Proposed Revisions to a Standard Plans Index

Index Number: 711-001

Sheet Number (s): 2 of 13

Index Title: Pavement Markings

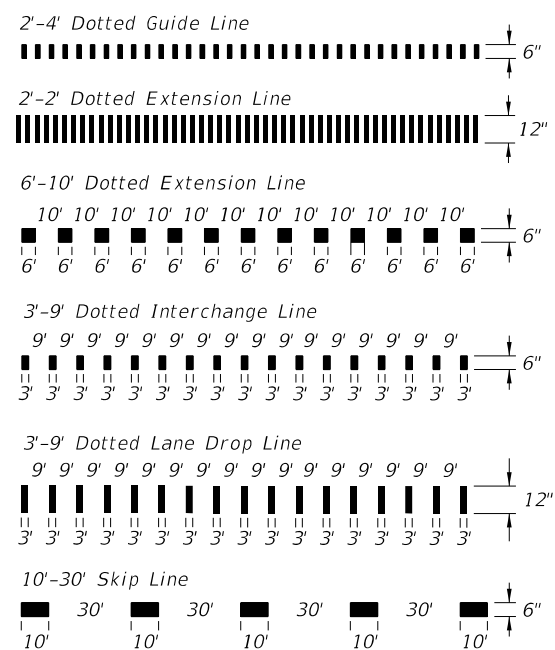
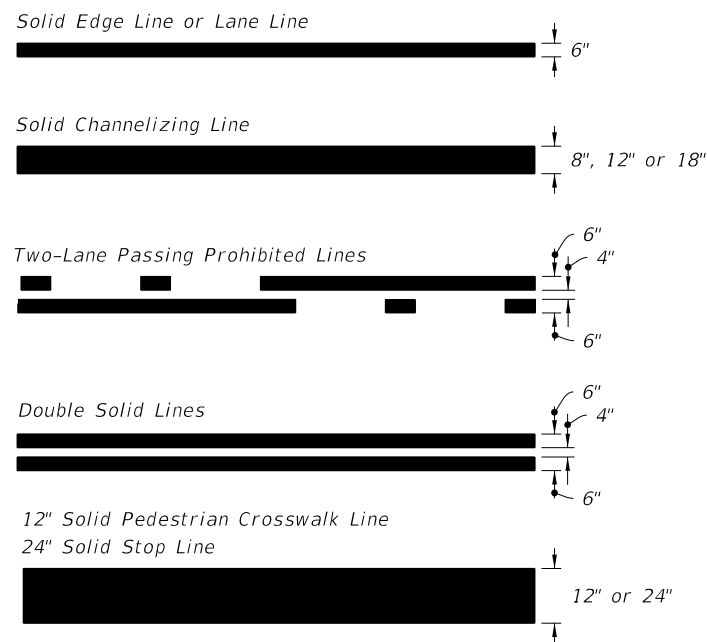
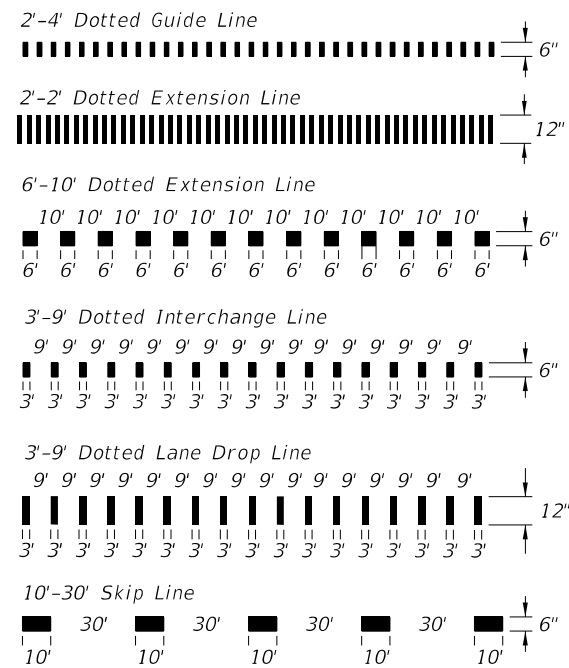
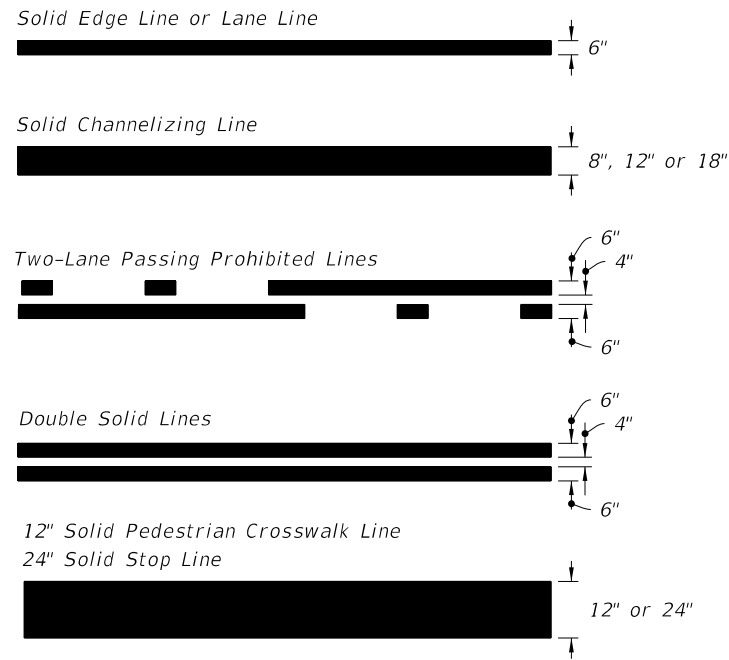
Sheet 2 : Changed "SHADOW" with "CONTRAST" in the 10-30' Skip Line and Dotted Line Details;
Added Longitudinal Solid Lane Line With Contrast Markings detail.

This change is being proposed to be consistent with other FDOT documents and MUTCD. The term "shadow markings" is undefined and inconsistent with the other documents.

LONGITUDINAL SOLID LANE LINE WITH CONTRAST MARKINGS

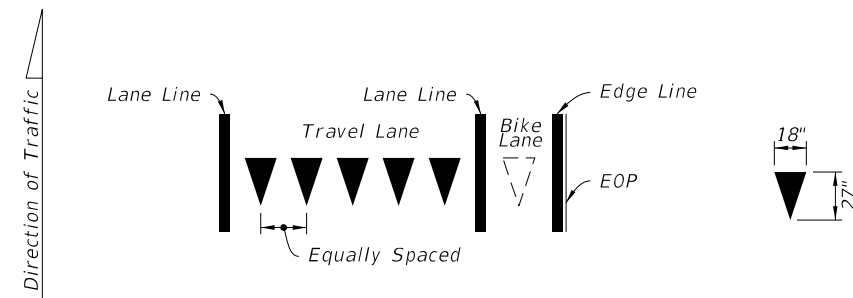
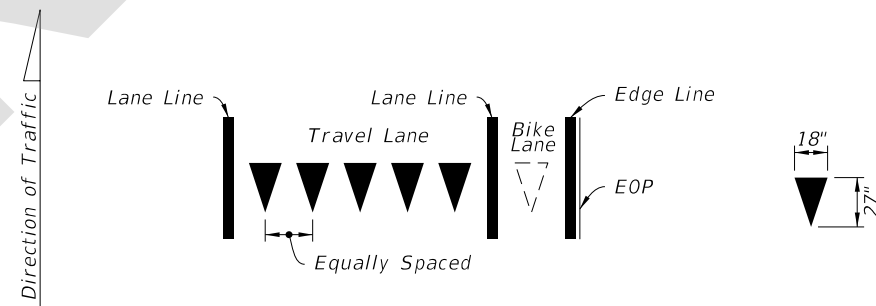
ADDED: Longitudinal Solid Lane Line With Contrast Markings detail.
11/01/22
